FUTURE MIDTOWN COLLECTION AT HANNAH RIDGE FILING NO. 3

CDR-20-11

MIDTOWN COLLECTION AT HANNAH RIDGE			
FILING NO. 3			
OVERLOT GRADING AND EROSION CONTROL PLAN			
DETAILS			
DESIGNED BY	KRC	SCALE	DATE 07/03/20
DRAWN BY	KC	(H) 1" = N/A	SHEET 3 OF 5
CHECKED BY		(V) 1" = N/A	JOB NO. 1116.35

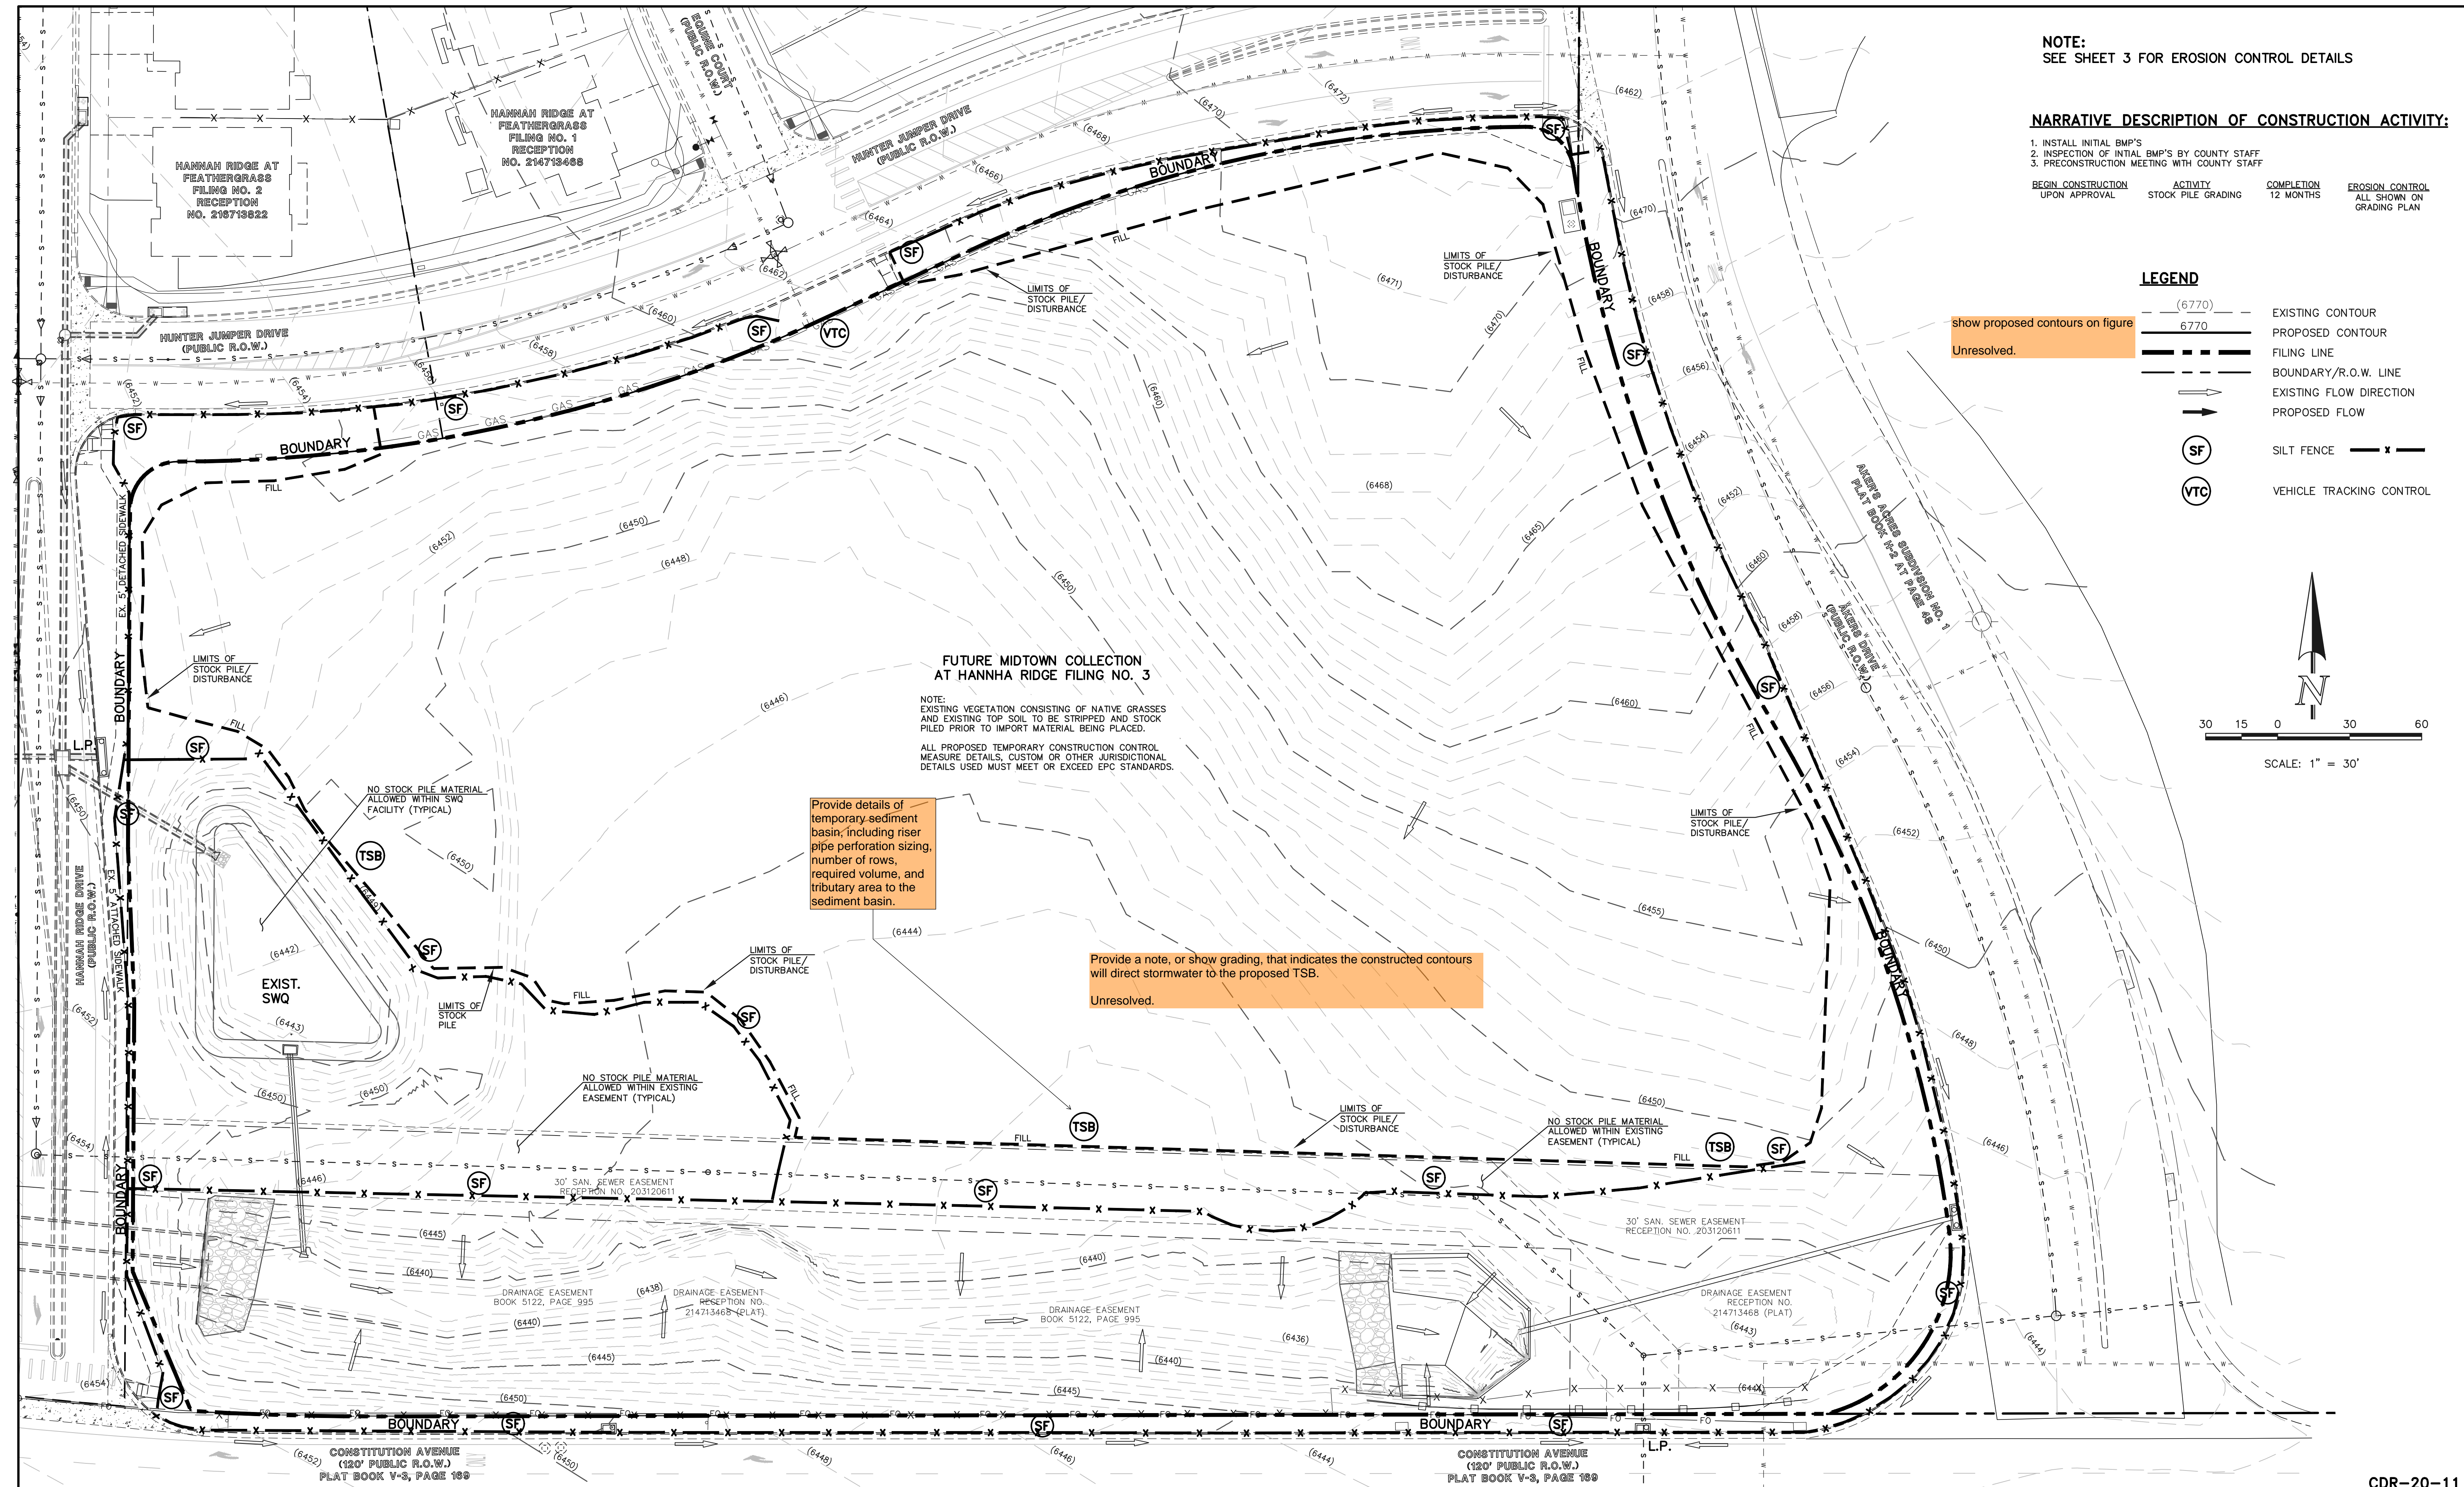
show proposed contours on figure
Unresolved.

Provide details of temporary sediment basin, including riser pipe perforation sizing, number of rows, required volume, and tributary area to the sediment basin.

Provide a note, or show grading, that indicates the constructed contours will direct stormwater to the proposed TSB.
Unresolved.
